**ADDENDUM NO. 2
TO THE**

**David C. McCollom Water Treatment Plant pH Control System Project
for Olivenhain Municipal Water District**

October 12, 2021

SHEET 09/28 OF SHEETS M-03
 D120068

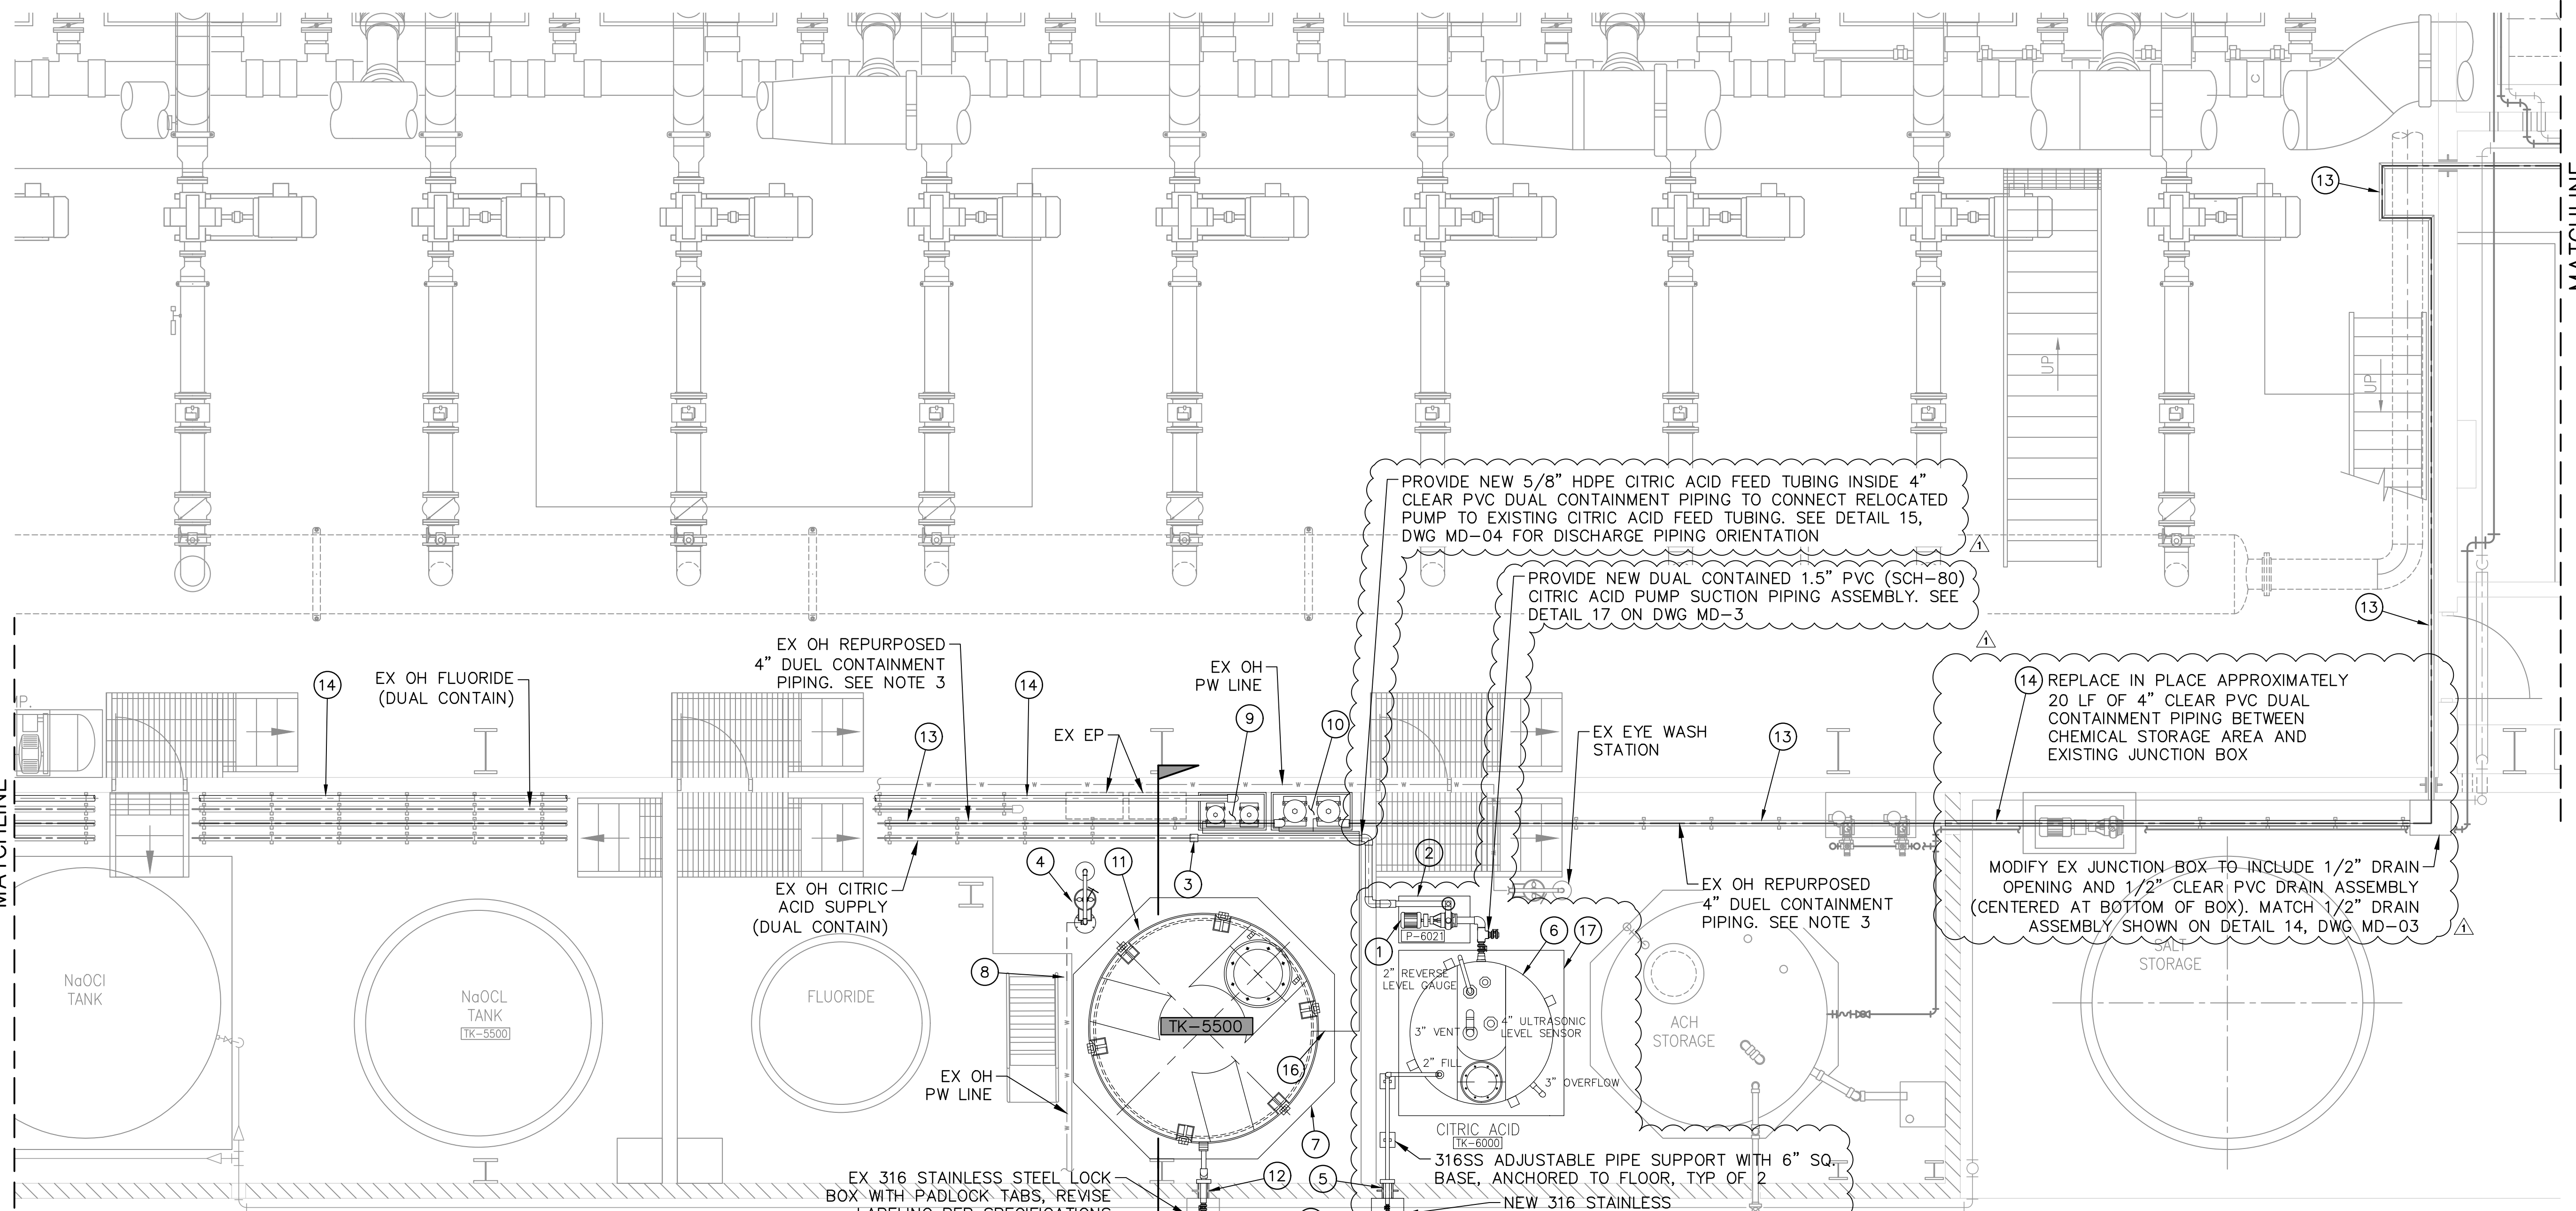
Q1. Sheet M-03, Plan View, Tank TK-6000 (Citric Acid), plans show a 2" drain connection at approx. 10:00 on the tank. This outlet is not shown on the Snyder tank drawing. Please confirm that the Snyder tank will have a 2" drain connection.

Q2. Sheet M-03, Plan View, Tank TK-6000 (Citric Acid), plans do not show an overflow for this tank, please note the Snyder Tank Drawing also does not show an overflow outlet. Please confirm that the Citric acid tank does not require an overflow line.

A: Tank Drain has been added to the tank outlet piping. See Revised Drawing M-03 and Detail 17 on Drawing MD-03

A: An overflow line is required. Contractor shall provide a 3" PVC overflow as shown on the REVISED Dwg M-03. The overflow shall be connected as shown on the drawing and the fill connection shall be relocated to the 2" port located on top of the tank as shown on REVISED Dwg M-03. Provide support struts as shown on the drawings. Locate the Reverse Level Sensor in the spare 4" port located on the top of the tank with a 4" x 2" reducer.
